RE: NH000-003-03-(053) – Clarke County
US78/SR10 (Atlanta Highway) over SR 10 Loop Interchange Improvement
PI No. 122890
Consultant QC/QA Certification Letter

FILE NH000-0003-03-(053), Clarke County **OFFICE:** Program Delivery
 P.I. No.: 122890
 US78/SR10 AT SR10 Loop Interchange **DATE:** February 15, 2011

SUBJECT **Revised Project Concept Report**

REVISED PROJECT CONCEPT REPORT

REVISION DATES	STATE OF GEORGIA DEPARTMENT OF TRANSPORTATION OFFICE - CONSULTANT DESIGN
	TYPICAL SECTIONS
	SR 10 LOOP/ATLANTA HIGHWAY INTERCHANGE
	DATE: 5-01

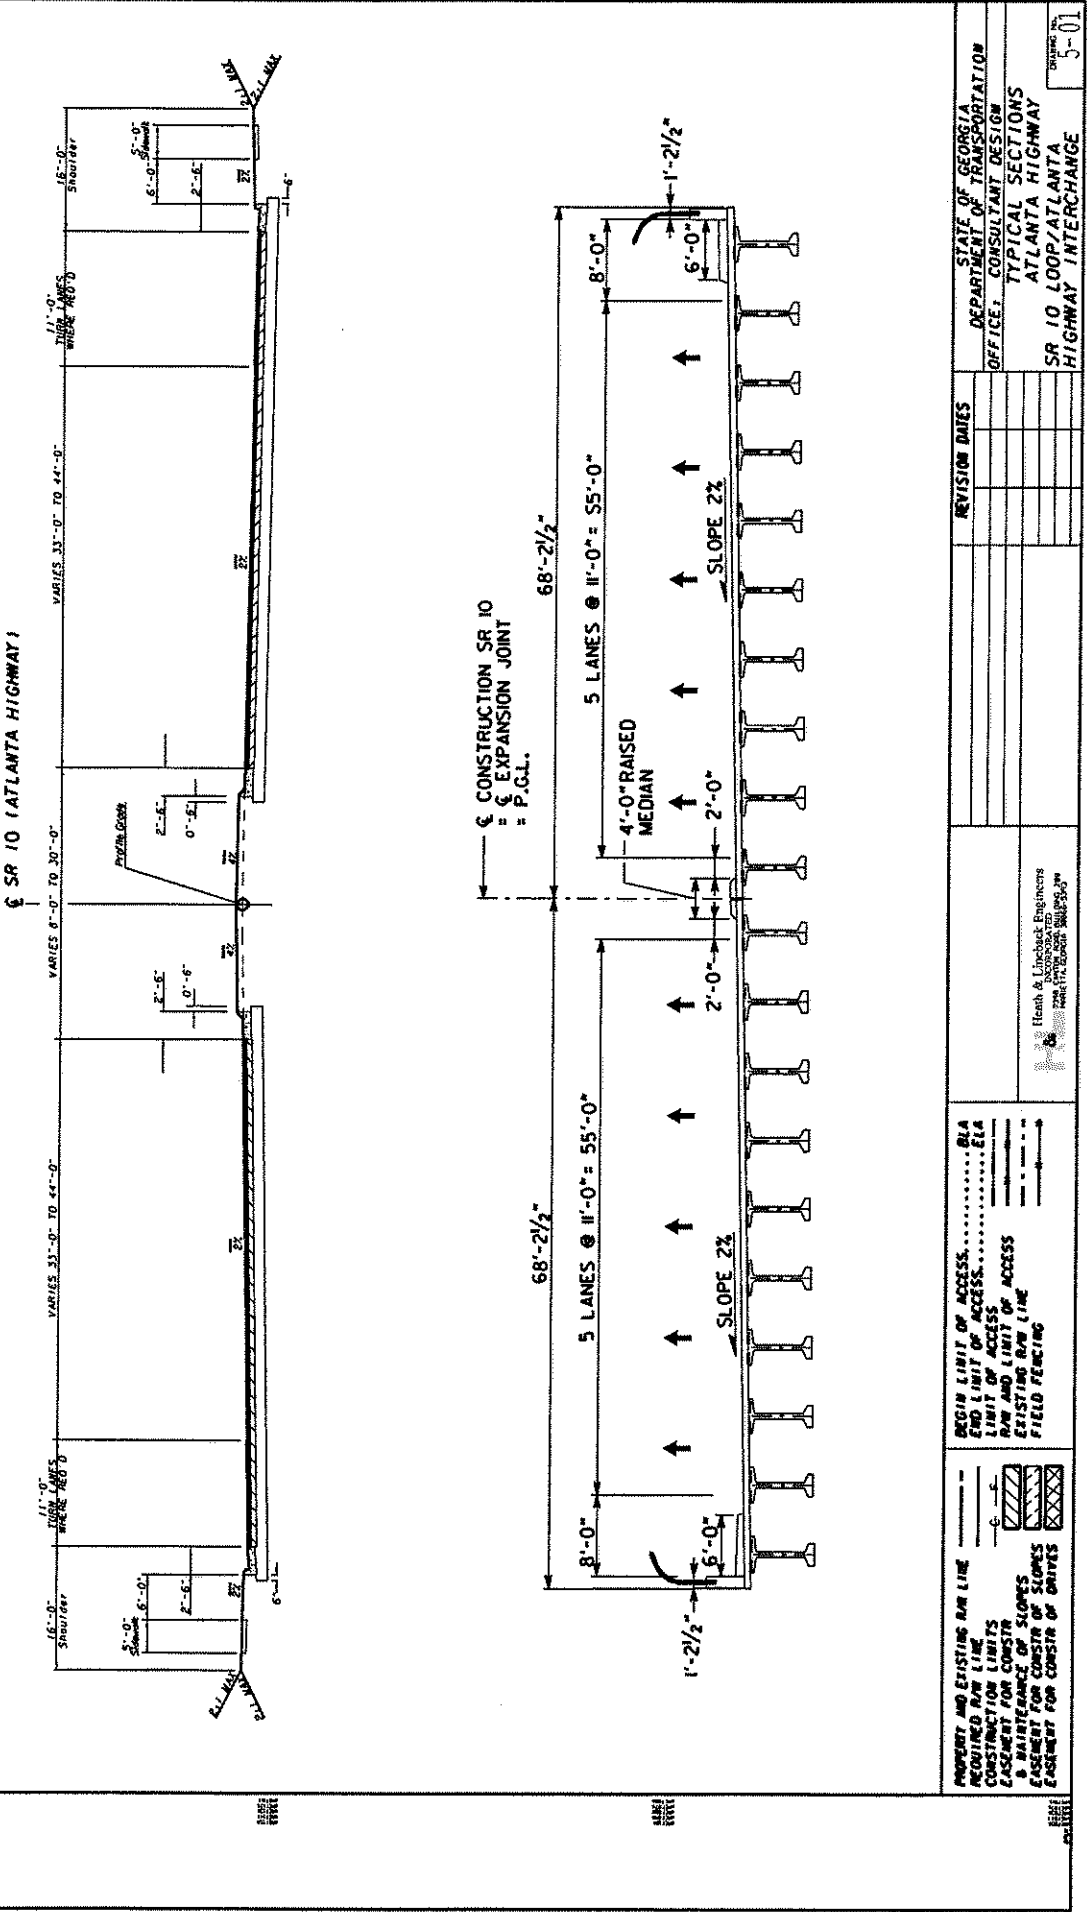
Typical Sections: The typical section for Atlanta Highway is to be revised to remove the 4 ft bike lanes and reduce the lane widths to 11 ft. The typical section for Huntington Road, Jennings Mill Road and all minor side roads will be revised to have 10 ft urban shoulders. These changes are due to a Value Engineering Implementation.

- The approved typical section for US 78 (Atlanta Highway) provides 12 ft travel lanes.
- The approved typical sections provide 4 ft bike lanes along both sides of US 78 (Atlanta Highway).
- The approved typical sections provide 16 ft wide urban shoulders along Huntington Road, Jennings Mill Road and all minor side road.

- The typical section for Atlanta Highway is to be revised to reduce lane widths from 12 ft to 11 ft due to a Value Engineering Study Implementation.
- The typical section for Atlanta Highway is to be revised to remove the 4 ft bike lanes due to a Value Engineering Study Implementation.
- Typical sections for Huntington Road, Jennings Mill Road and all minor side roads are to be revised to reduce the shoulder width from 16 ft to 10 ft, due to a Value Engineering Study Implementation. This is accomplished by reducing the width of the 6 ft grass

buffer area to 2 ft and the 2.5 ft grass area outside the sidewalk to 6 inches.

ROW is the highest cost item on this project. Reducing the pavement section widths and shoulder widths will result in significant cost savings (pavement and ROW) and also reduce / minimize the amount of new ROW required to construct the project.
The bike lane would not tie to any proposed bike routes designated by GDOT or Athens-Clarke County.
